## PRODUCT CHANGE NOTIFICATION

Date: April 20, 2016  
PCN: PCN LEDIL 117

**Subject:** PCN 117- Change of positioning pin locations in STRADA-2X2-T1 lens

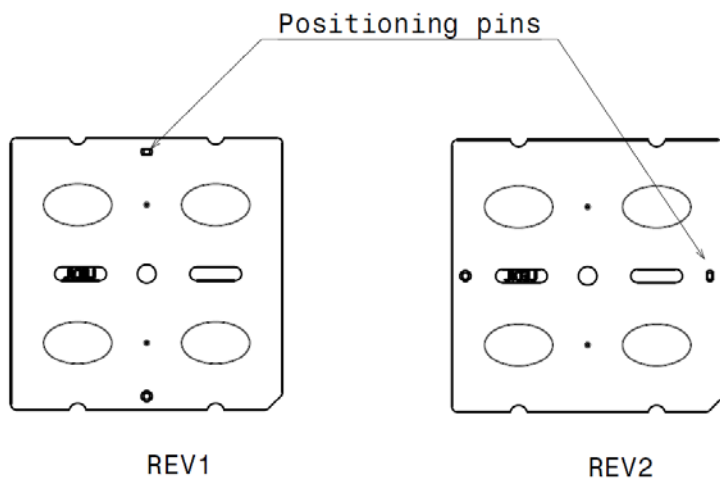
**Description:** C15135\_STRADA-2X2-T1 street lighting lens is providing an asymmetrical light distribution that was not conforming to the product family because of 90 deg different beam direction compared to other similar products within STRADA-2X2 product family. Therefore LEDiL has changed two positioning pin locations to ensure better inter-product compatibility. The change will affect the lens to be assembled 90 deg differently on the PCB than before.

**Changes:** The two positioning pins of C15135\_STRADA-2X2-T1 change rotation to
